LONG CHIH INDUSTRIAL COMPANY LIMITED
101, Show Shan Road, Shinchuang City, Taipei Hsien, Taiwan, ROC
Tel: 886-2-29068666 Fax: 886-2-2906-8669 E-mail: longchih@ms31.hinet.net

SAFETY RECALL NOTICE

Long Chih -- trailer manufacturer has decided that all our trailers manufactured from September 1, 2005 to December 31, 2008 fail to conform to Federal Motor Vehicle Safety Standard No. 110. "Tire Selection and Rims." These trailers are missing the tire placard label which states the tire size, tire pressure, and maximum load information. The gross vehicle weight rate (GVWR) on the VIN plate on some of the trailers is incorrect and the GVWR and gross axle weight rate (GAWR) units should be specified in pounds on the VIN plate. Also, the owner's manual is missing the information to report suspected safety defects as required by Federal Regulation Title 49 CFR Part 575 "Consumer Information." A misprinted label could lead to improper vehicle loading specification or tire inflation which could result in a tire failure, increasing the risk of a crash.

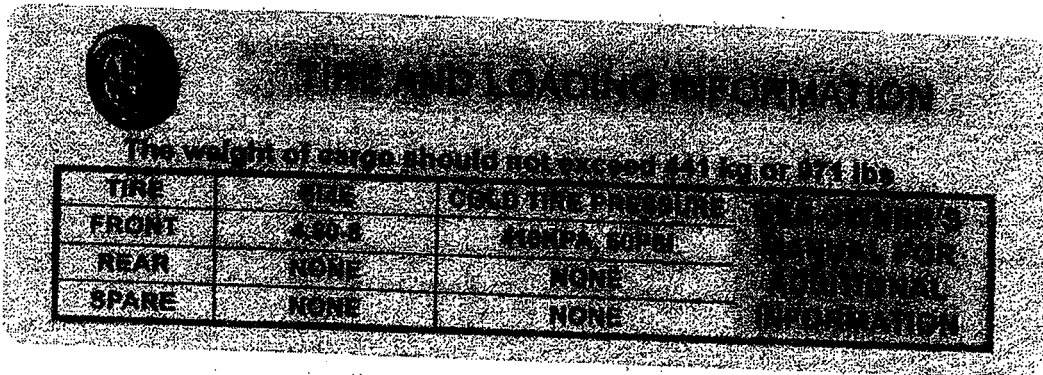
Enclosed with this letter is the correct tire placard label and GVWR label. Please affix these labels to the driver's side of the trailer tow bar near the VIN plate as shown below in this picture. Also enclosed is the "Reporting Safety Defects" statement as a part of owner's manual. Please read this statement and save it with

1. Clean the surface of the tow bar driver's side as on above diagram.
2. Please affix the provided corrected GVWR label first then tire placard on clean surface of tow bar.

GVWR & GAWR for HT-92796 Trailer Kit(sticker)

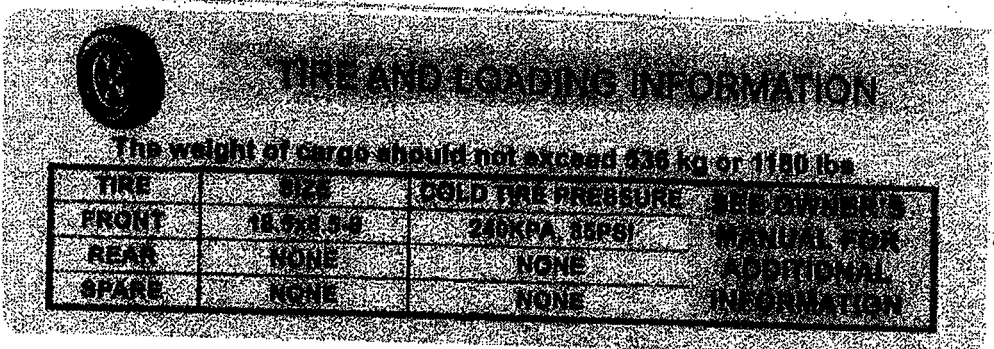
TIRE AND LOADING INFORMATION

The weight of cargo should not exceed 141 kg or 311 lbs

TIRE	SIZE	COLD TIRE PRESSURE	SEE OWNER'S MANUAL FOR ADDITIONAL INFORMATION
FRONT	4.00-8	480KPA (70PSI)	
REAR	NONE	NONE	
SPARE	NONE	NONE

GVWR-530 KGS, 1170 LBS
